Re: Agreement Amendment No. 2
Olbrich Botanical Gardens Expansion – Phase I
Vierbicher Project #160322

Date: 1/9/2019
Project Name: **City of Madison: Olbrich Botanical Gardens Expansion**
Project No: 2017016.00

Re: **Design Contract 8717 – Amendment #2: Additional Design Services.**
Initial Letter dated Nov 26, 2018.

**Olbrich Botanical Gardens
Expansion Phase 1**
BPW Project #8162
3330 Atwood Avenue
Madison, WI 53704

**EXHIBIT A
G051**

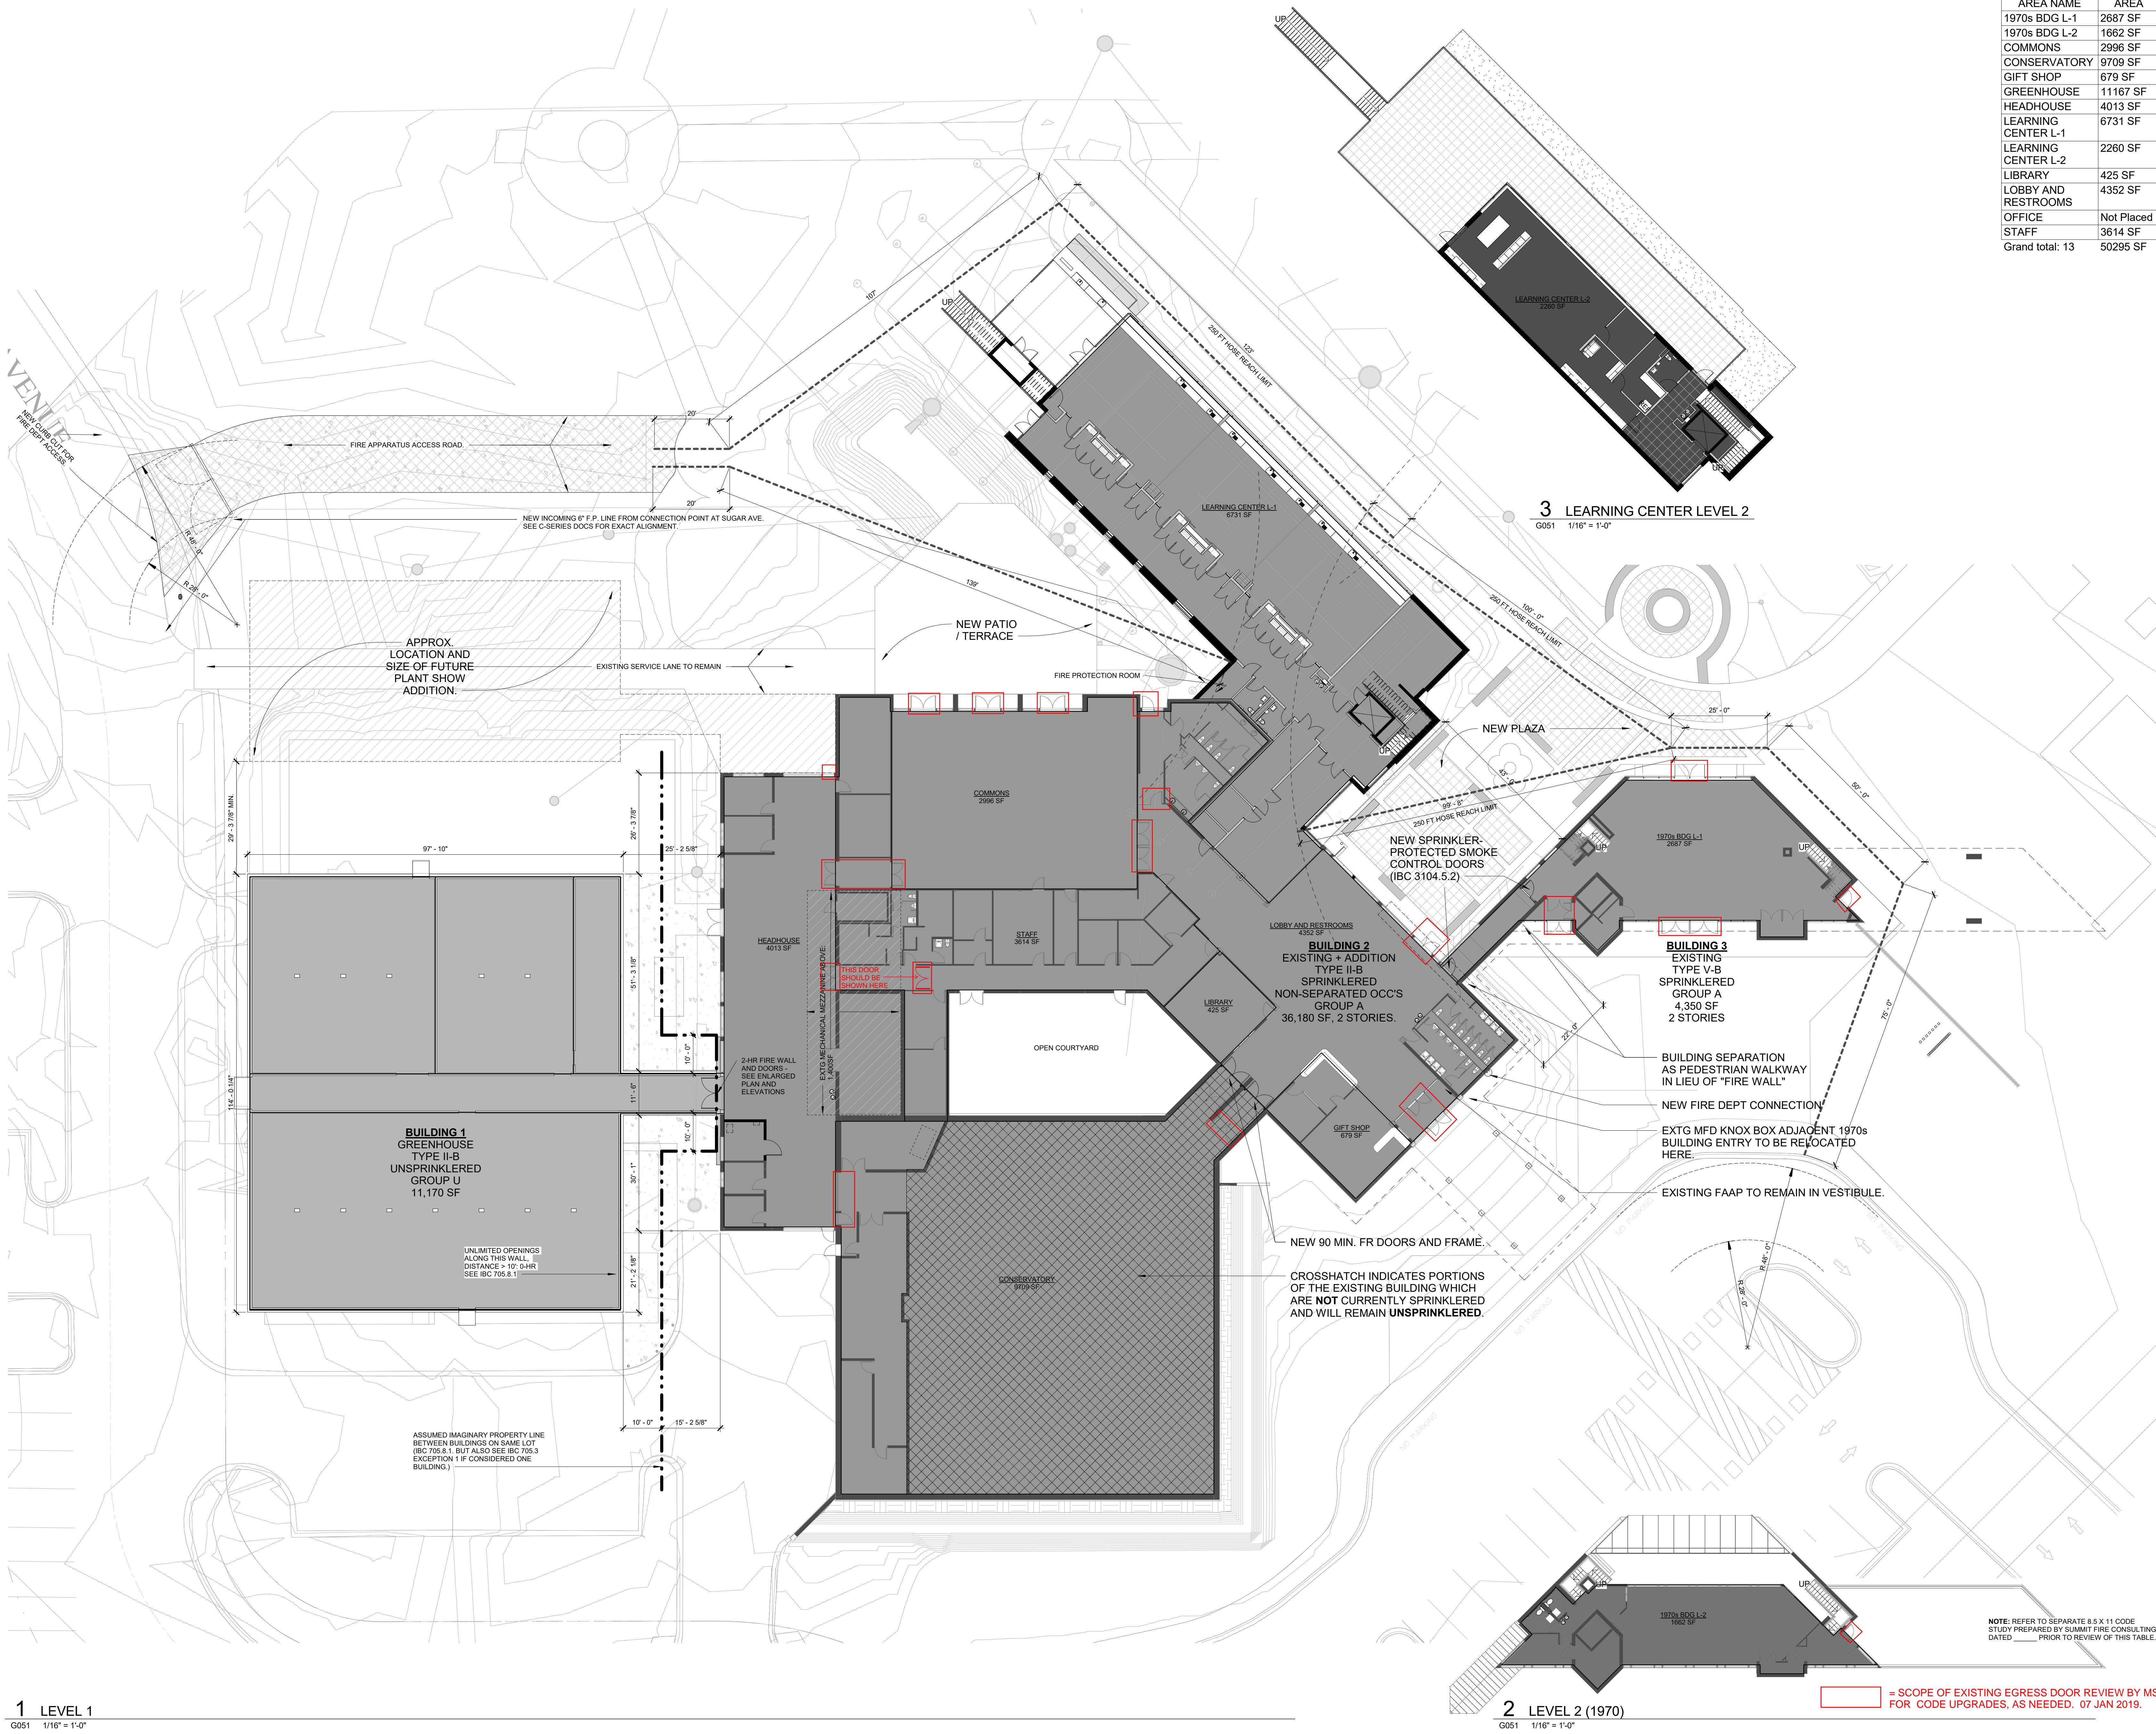
The attached code plan sheet G05 I from the current construction set is marked up indicating the location of all existing doors on egress pathways requiring auditing. There are (24) door openings in total, and we anticipate the following time needed for this effort:

□ = SCOPE OF EXISTING EGRESS DOOR REVIEW BY MSR FOR CODE UPGRADES, AS NEEDED. 07 JAN 2019.
